WATER PERMIT NO. 1845-1

Name of Applicant: Meade School District 46-1

Application For Permit To Appropriate Water Within The State Of South Dakota

WATER PERMIT APPLICATION NO. 1845-1
MEADE SCHOOL DISTRICT 46-1
JUNE 21, 2005

WELL LOCATION EXHIBIT

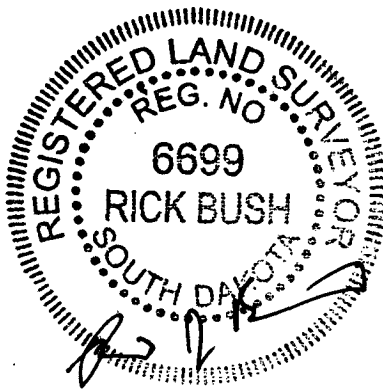
- Enclosed is the map. The map needs to show the location of the well in relation to a government section corner or quarter corner by direction and distance is required.

*Enclosed Please find the
new map.*
